Subject: Operator Initial License Examination Post Examination Materials
Waterford Steam Electric Station, Unit 3 (Waterford 3)
Docket No. 50-382
License No. NPF-38

Operator Initial License Examination Post Examination Materials

2012 NRC Written Exam Item Analysis

RO Question 9

FIG. 04 RPS SIMPLIFIED DIAGRAM

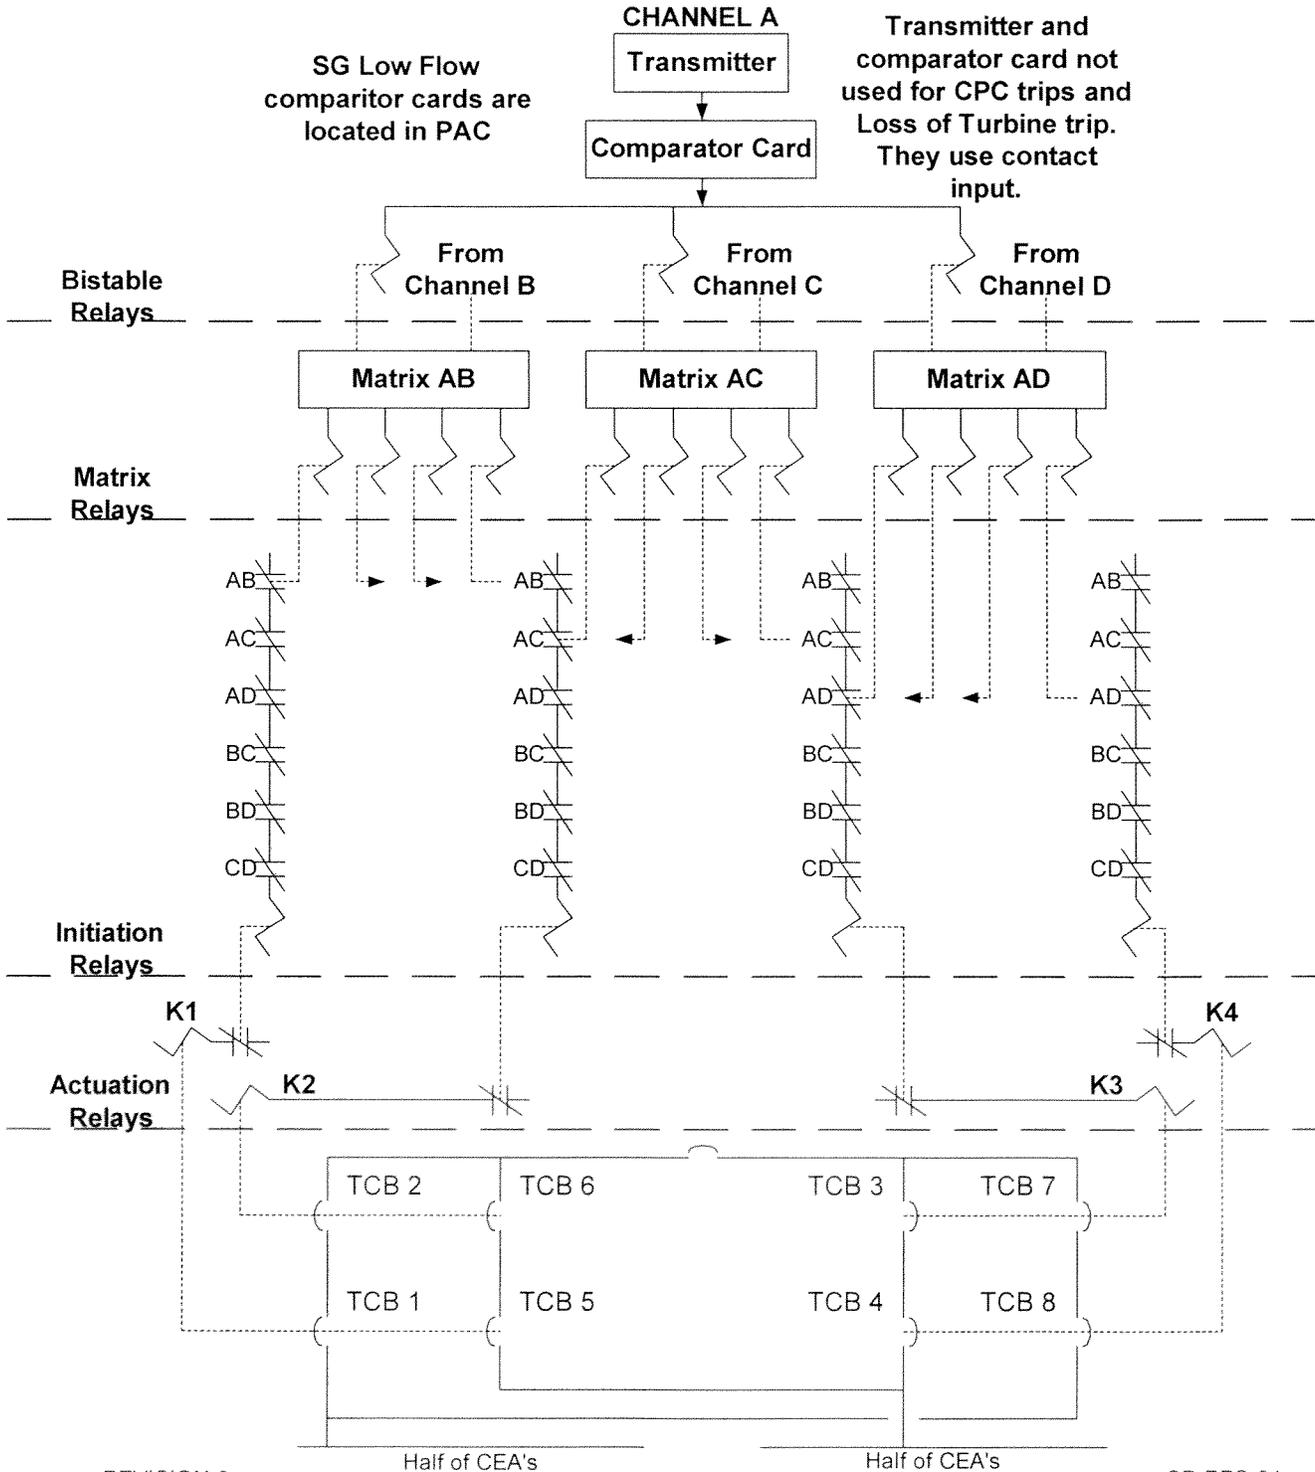
As shown on system description figure 8, the Trip Matrix ladder would deenergize if any one bistable contact opened. If the K101 contact for low steam generator level failed to change state (or any other card or relay in the generation of the low steam generator level signal), there would be no actuation in PPS. If the low DNBR K101 contact subsequently changed state, an actuation signal would be generated.

Control wiring diagram 5 shows the Reactor Trip breaker wiring. The push buttons on CP-2 are displayed in the top center of the diagram. The K1 relay contacts in the bottom center portion, located in CP-10, are the contacts operated by the PPS actuation relays shown at the bottom of figure 4.

For the reasons cited above, we request a change to the answer key to allow both selections B and D to be correct. The basis for this request is that the question stem did not provide all the necessary information, allowing 2 choices to be technically correct.
